Product Change Notification / RMES-15BFRM526

CCB 6068 Final Notice: Qualification of STAR as an additional final test site for MICRF219AAYQS, MICRF219AYQS, MICRF220AYQS, MICRF219AAYQS-TR, MICRF219AYQS-TR, MICRF220AYQS-TR, and SPN111001Y-TR catalog part numbers (CPN) available in 16L QSOP (.150in) package.

CCB 6068

PCN #: RMES-15BFRM526

Pre and Post Change – Plastic Reel

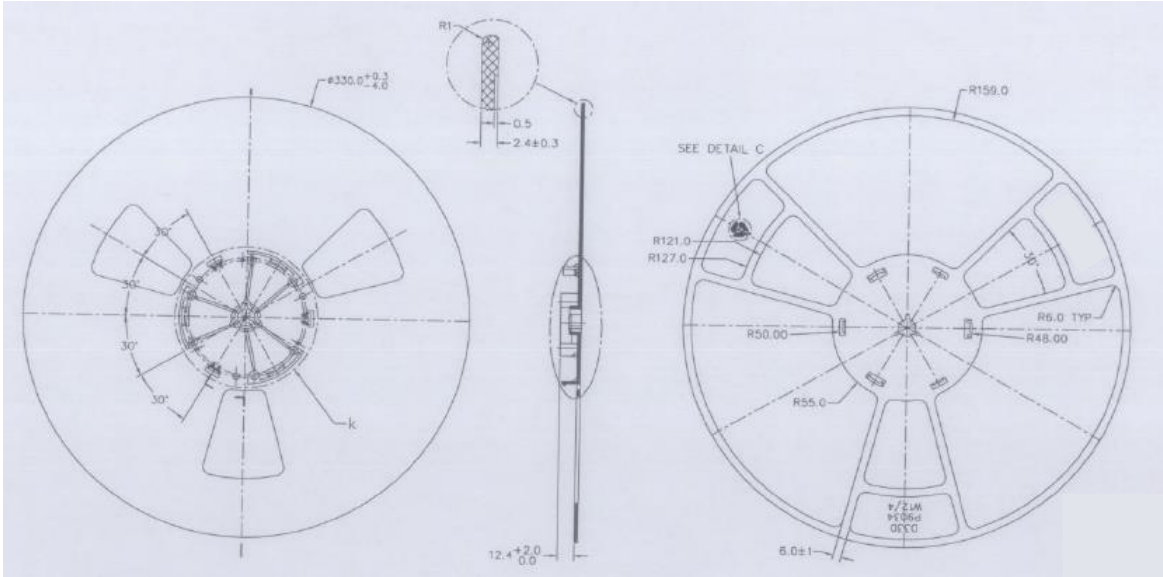
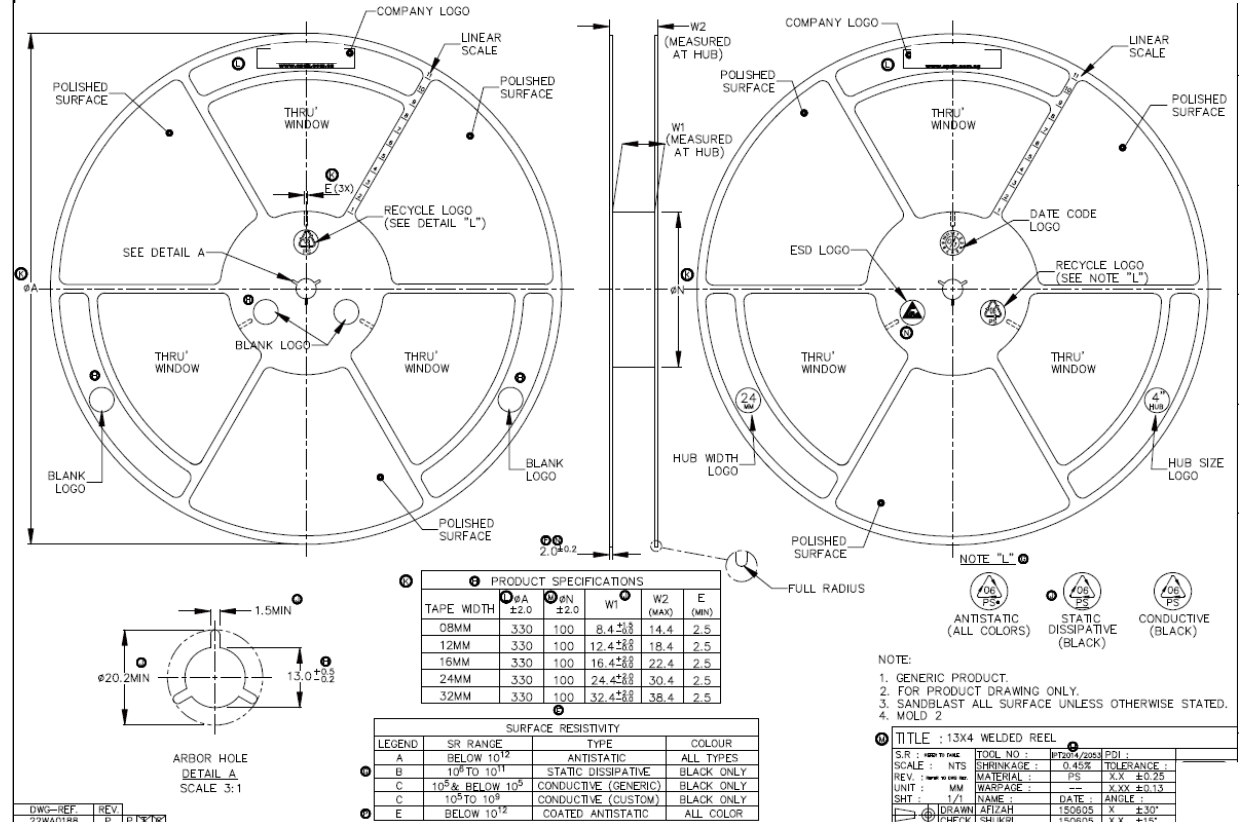
Note: No change in dimension and appearance.

Pre and Post Change – Carrier Tape

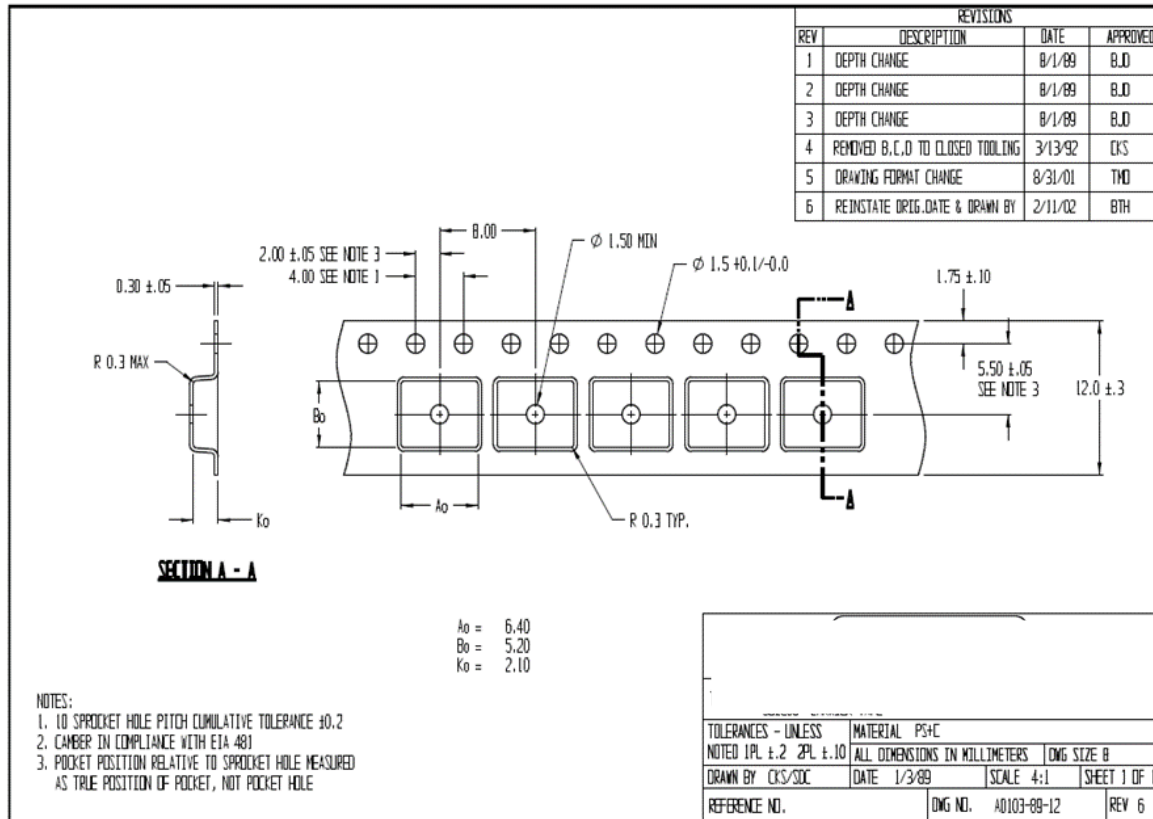
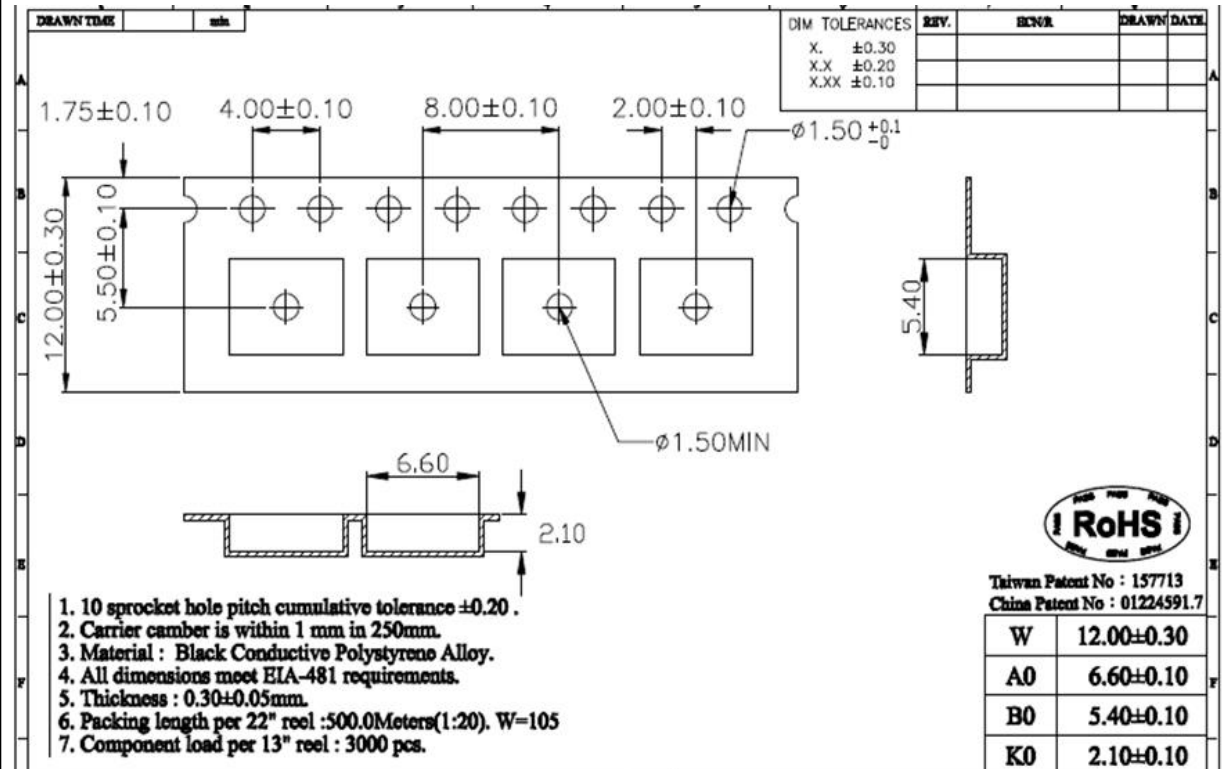
Plant	W (mm.) ± 0.3 or Specific	P (mm.) ± 0.1 or Specific	A ₀ ± 0.1 or Specific	B ₀ ± 0.1 or Specific	K ₀ ± 0.1 or Specific
UNIS	12	8	6.40	5.20	2.10
STAR	12	8	6.60	5.40	2.10

Pre and Post Change – Cover Tape

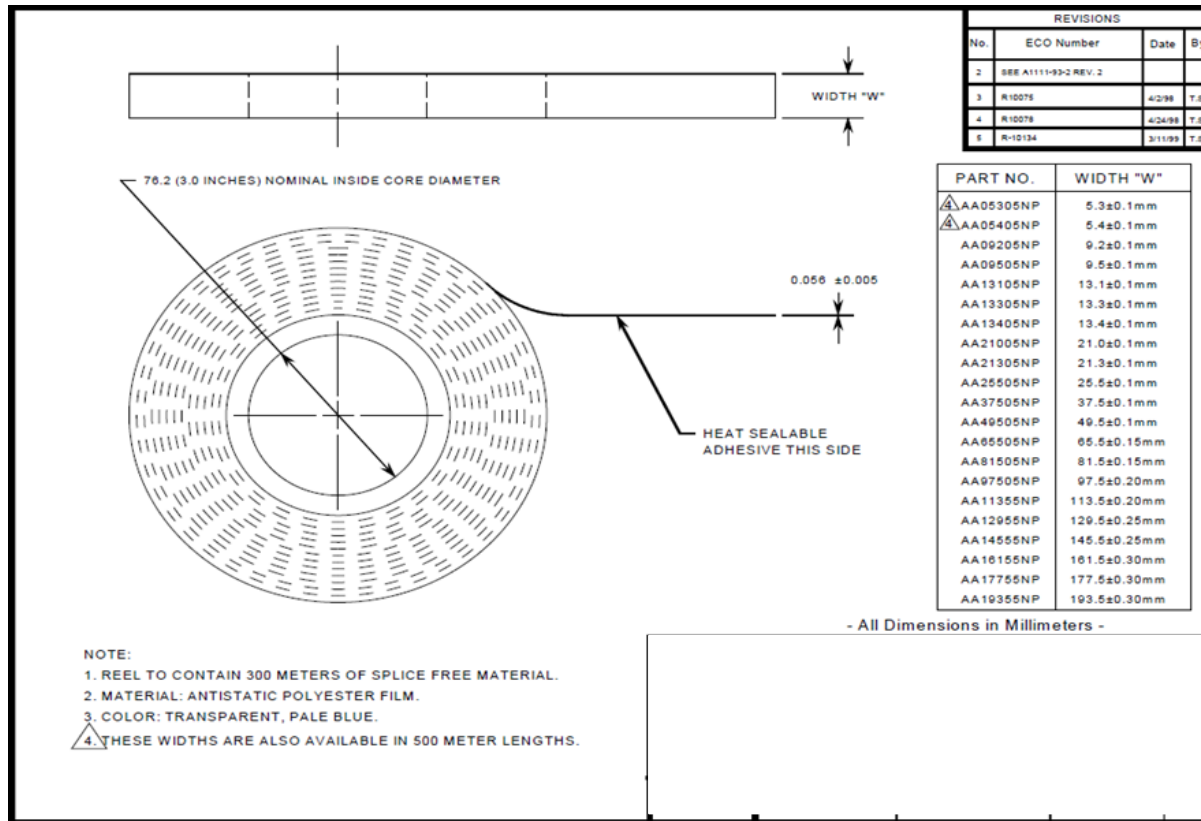
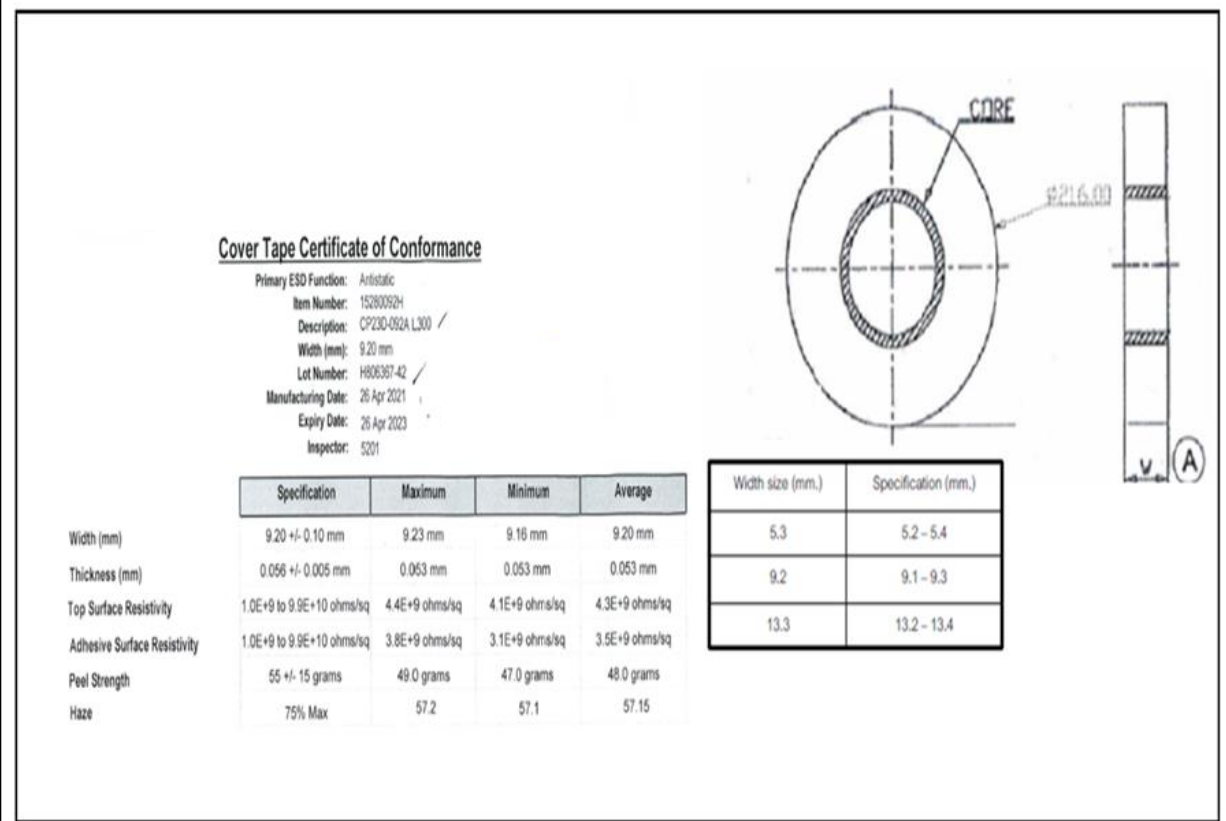
Plant	Carrier Tape Width	Cover Tape Width	Thickness	Color	Sealing mythology
UNIS	16mm	13.3 +/-0.1mm	0.056+/-0.005	Clear	Heat sealing
STAR	16mm	13.3 +/-0.2mm	0.050+/-0.005	Clear	Heat sealing

Pre and Post Change – Tape and Reel Packing Method

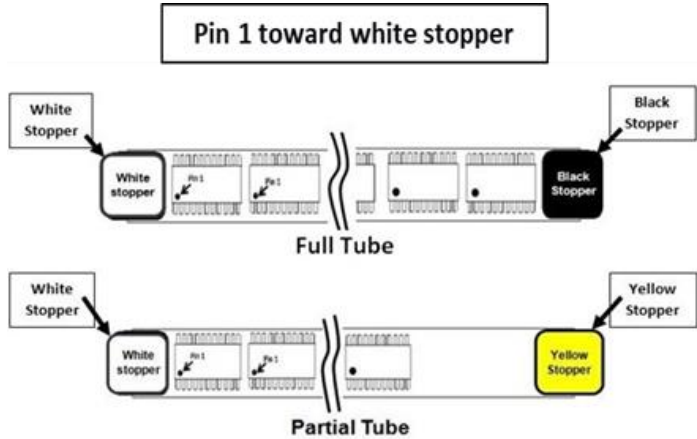
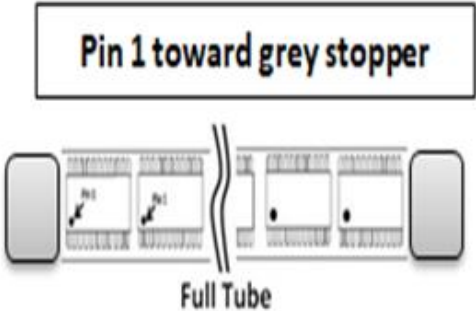
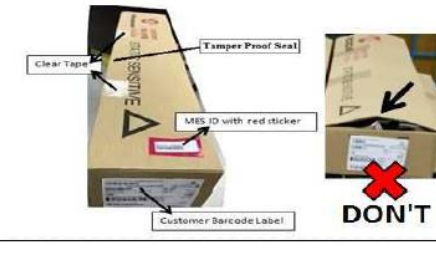
UNIS	STAR
 <p>Microchip Barcode label</p> <ol style="list-style-type: none"> 1) 13" Blue Reel - D330-P9034-W12/4 (P/N: 47370032) 2) Microchip Barcode label (P/N: 50320185) 3) 12mm Protective band (P/N: 47560001) 	
<div> <div> <p>Front</p>  <p>ESD LOGO Customer Barcode Label</p> </div> <div> <p>Back</p>  <p>Adhesive ESD tape</p> </div> </div> <ol style="list-style-type: none"> 1) Static Shield Bag 16"X16" (P/N: 50020046) 2) Microchip Standard Barcode Label (P/N:50320185) at below ESD Logo <p>Back:</p> <ol style="list-style-type: none"> 1)Seal Antistatic shield bag with adhesive ESD tape. 	
<div> <div>  <p>ESD LOGO Customer Barcode Label</p> </div> <div>  <p>Antistatic Bubble bag</p> </div> </div> <ol style="list-style-type: none"> 1)Quantity/box = 1 reel 2) Use antistatic bubble bag sheet fill in the space if much space inside the box 	
 <p>MES ID with red sticker Customer Barcode Label Clear Tape</p> <ol style="list-style-type: none"> 1) Microchip Box = M02-009 Brown-Pizza-13" (P/N: 50080187) 2) Microchip Standard Barcode Label (P/N:50320185) at left side of box opening 3) Red sticker with MES ID at right side of box opening 4) Seal box opening with clear tape at the middle <p>(Note: Remove red sticker with MES ID before ship to customer)</p>	 <p>Packing in Reel 13 Inch Insert Reel in static shielding bag Packing in box Put label</p>
